**NOTICE OF ADDENDUM  
ADDENDUM NO. 1  
ICE AGE JUNCTION PATH AND JEFFY PATH  
AND  
JEFFY TRAIL SANITARY SEWER ASSESSMENT DISTRICT  
CONTRACT NO. 6886**

ICE AGE JUNCTION & JEFFY PATHS PROJECT NO. 53WI348		SHEET NO. W-2
WATER PLAN AND PROFILE		
JEFFY SIDEWALK XING	CITY OF MADISON	
PM: DENNIS CAWLEY	DESIGNER: PEH	REVISED 6/6/2013

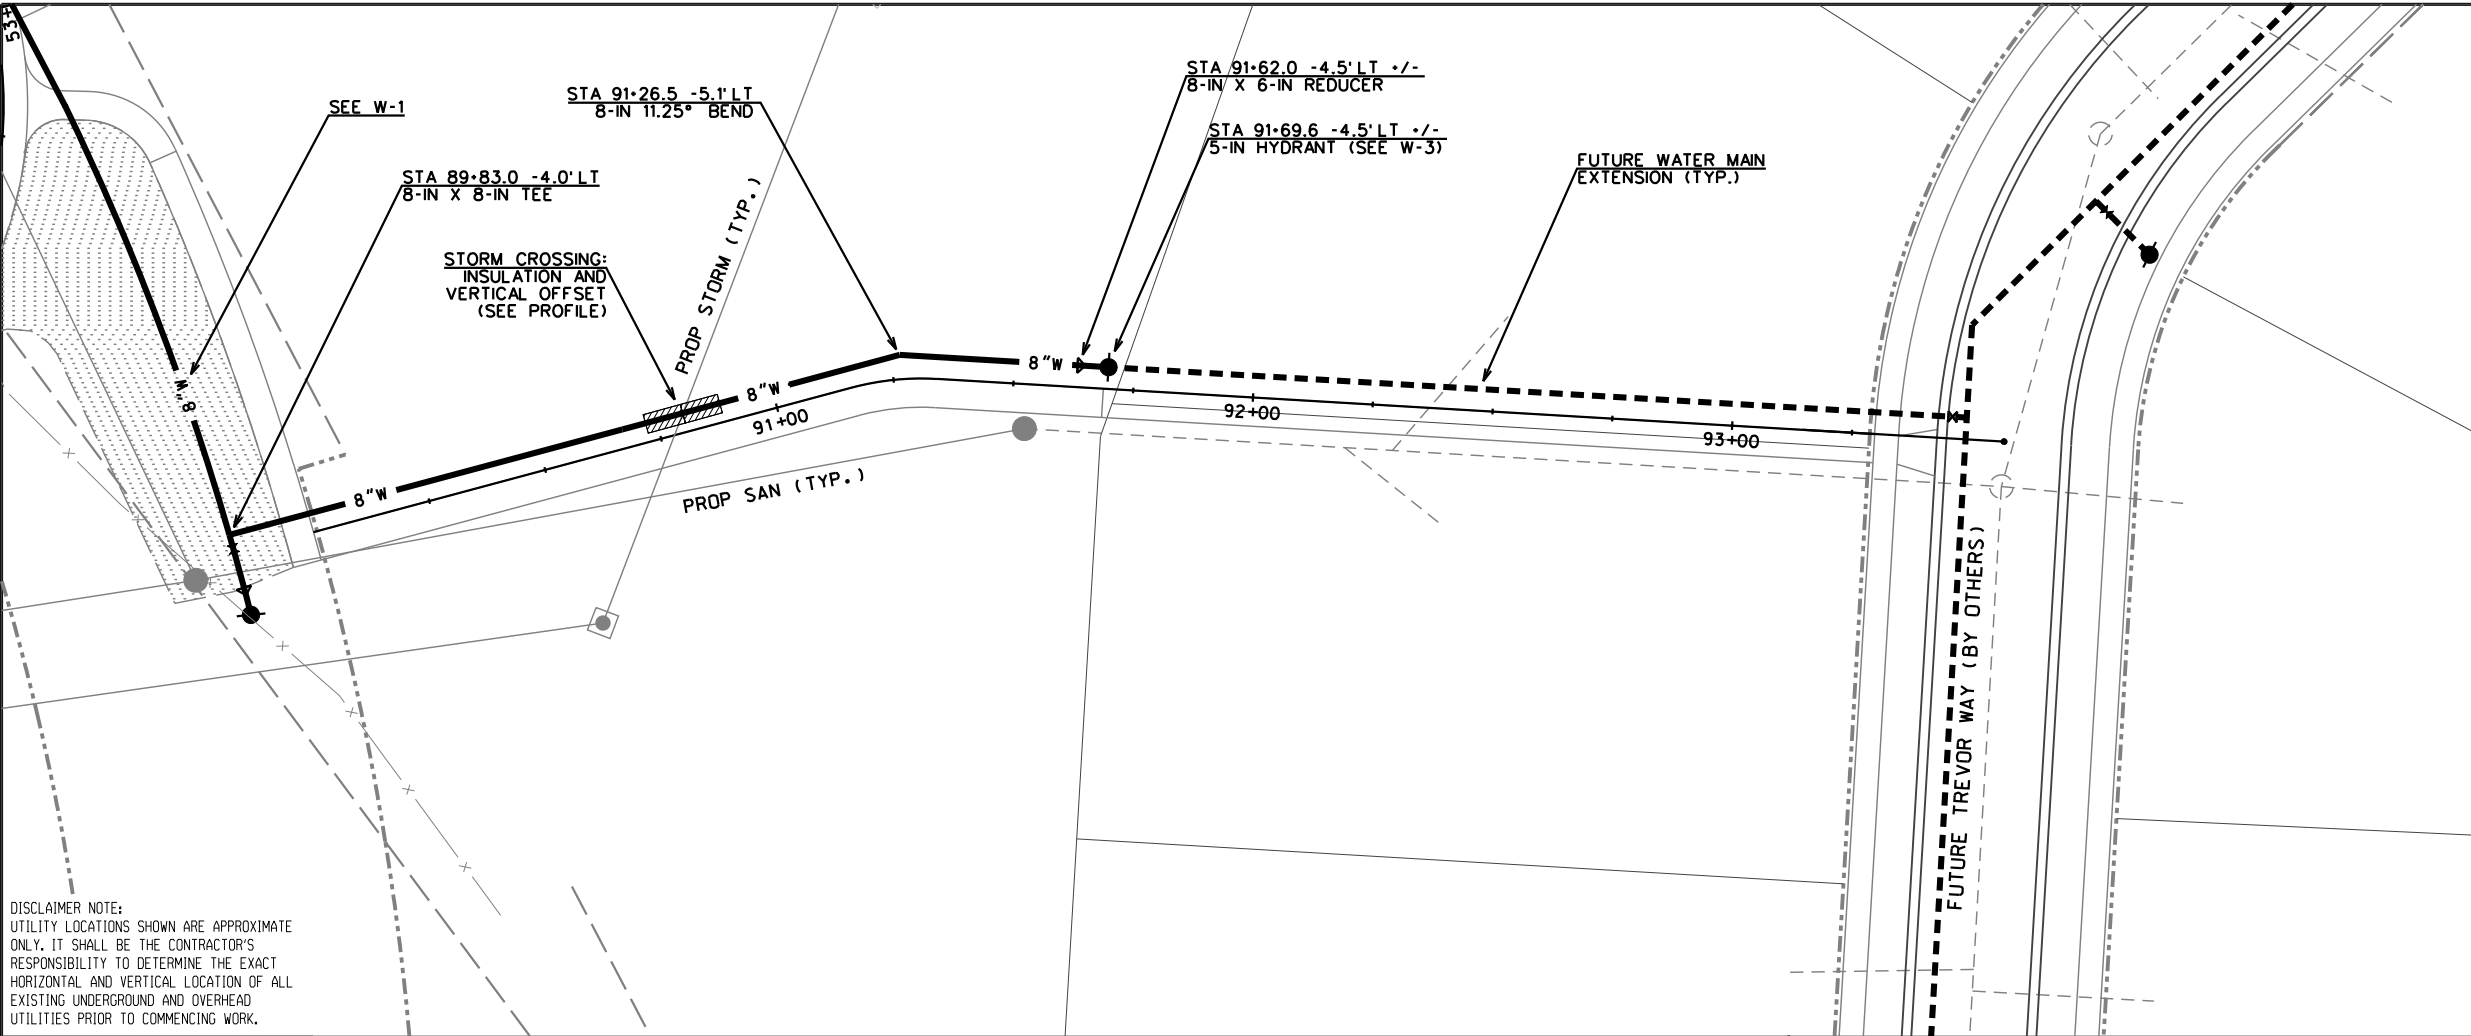
Replace Sheet W-2 of the **PLANS** with revised Sheet W-2 dated 6/6/13 and discard old sheet. Sheet is updated with correct location of the reference line and station/offset notes. There is no change in the proposed water main or quantities.
